CITY OF ALBUQUERQUE

**Re: Lot 39 Block 5 Volcano Cliffs Unit 5
8020 Monte Carlo Dr. NW
Grading & Drainage Plan
Engineer's Stamp dated: 2-28-21 (E10D101)**

DRAINAGE AND TRANSPORTATION INFORMATION SHEET (REV 6/2018)

Lots 39, Block 5, Volcano Cliffs Subdivision, Unit 5
8020 monte Carlo Dr., NW
GRADING PLAN

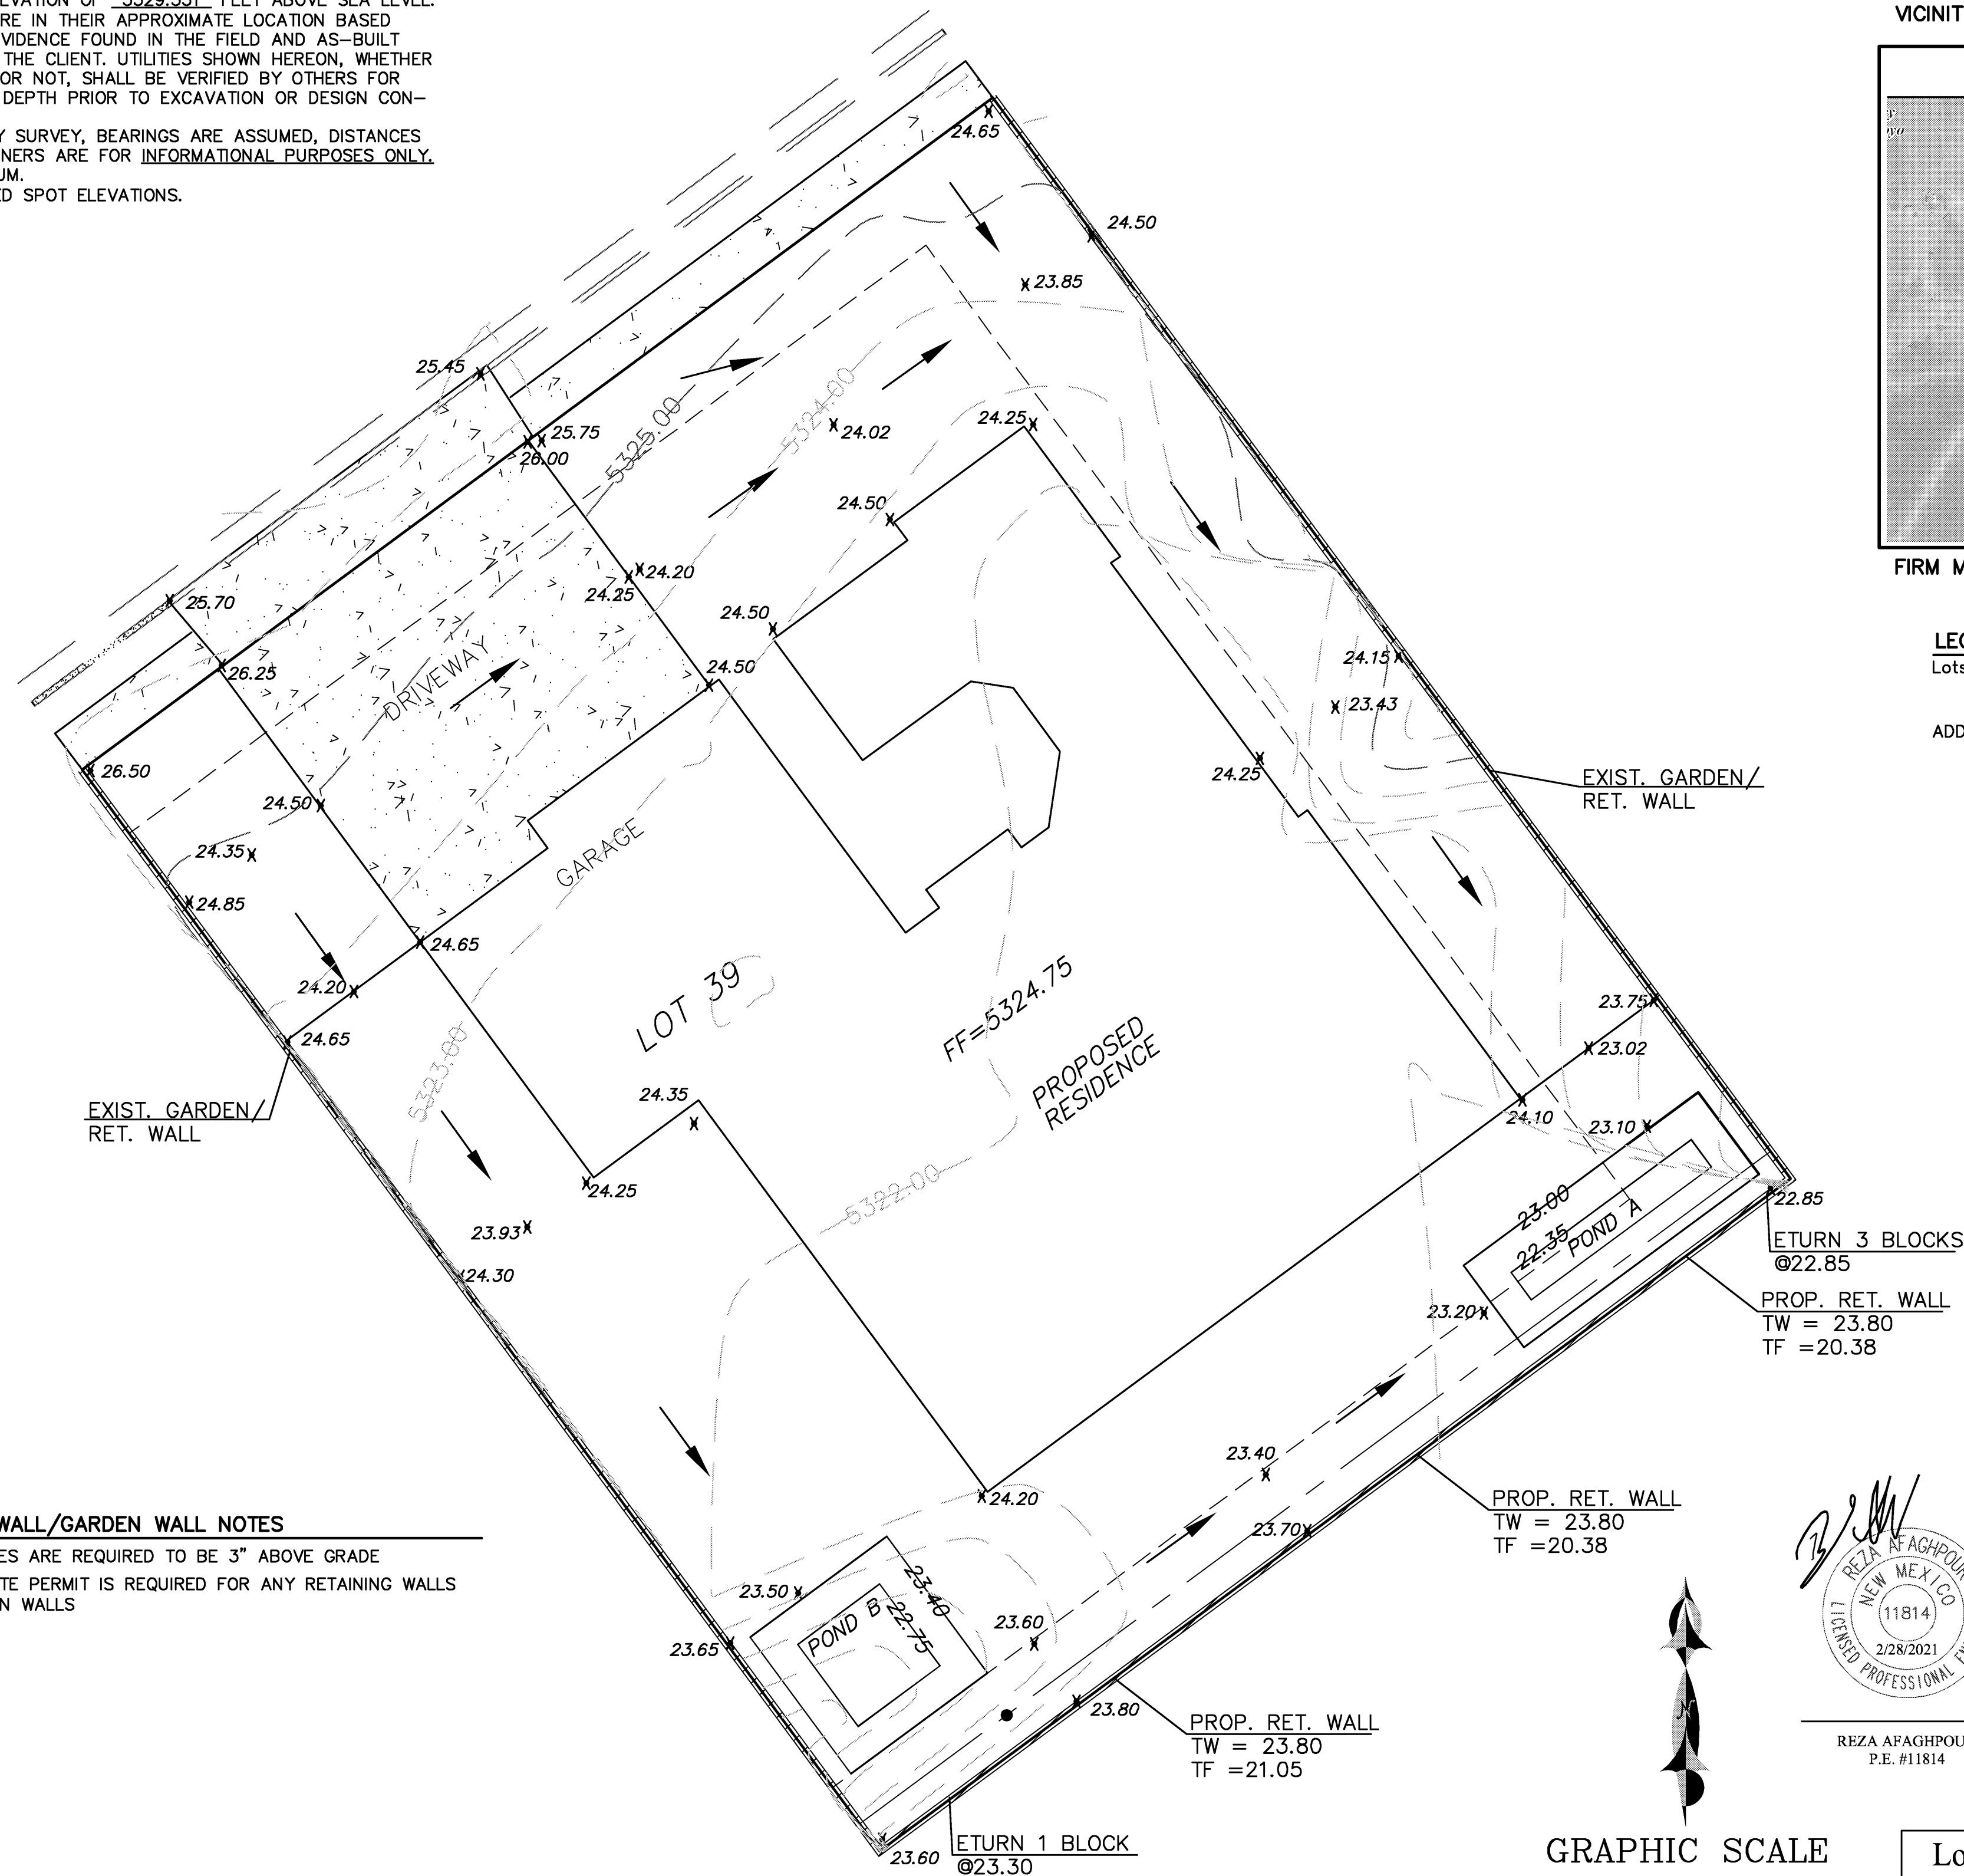
Based upon the information provided in your submittal received 3/22/2021, this plan is approved for Grading Permit.

Albuquerque Reiterate to the Owner/Contractor that a separate permit for a garden/retaining wall must be obtained, with the approved G&D plan dated 2/2/18.

NM 87103 **Prior to Building permit approval a Pad Certification will be required**, provided by the Engineer with pad cert language or a registered Land Surveyor with as build spot elevations.

www.cabq.gov Prior to Certificate of Occupancy release, Engineer Certification per the DPM checklist will be required.
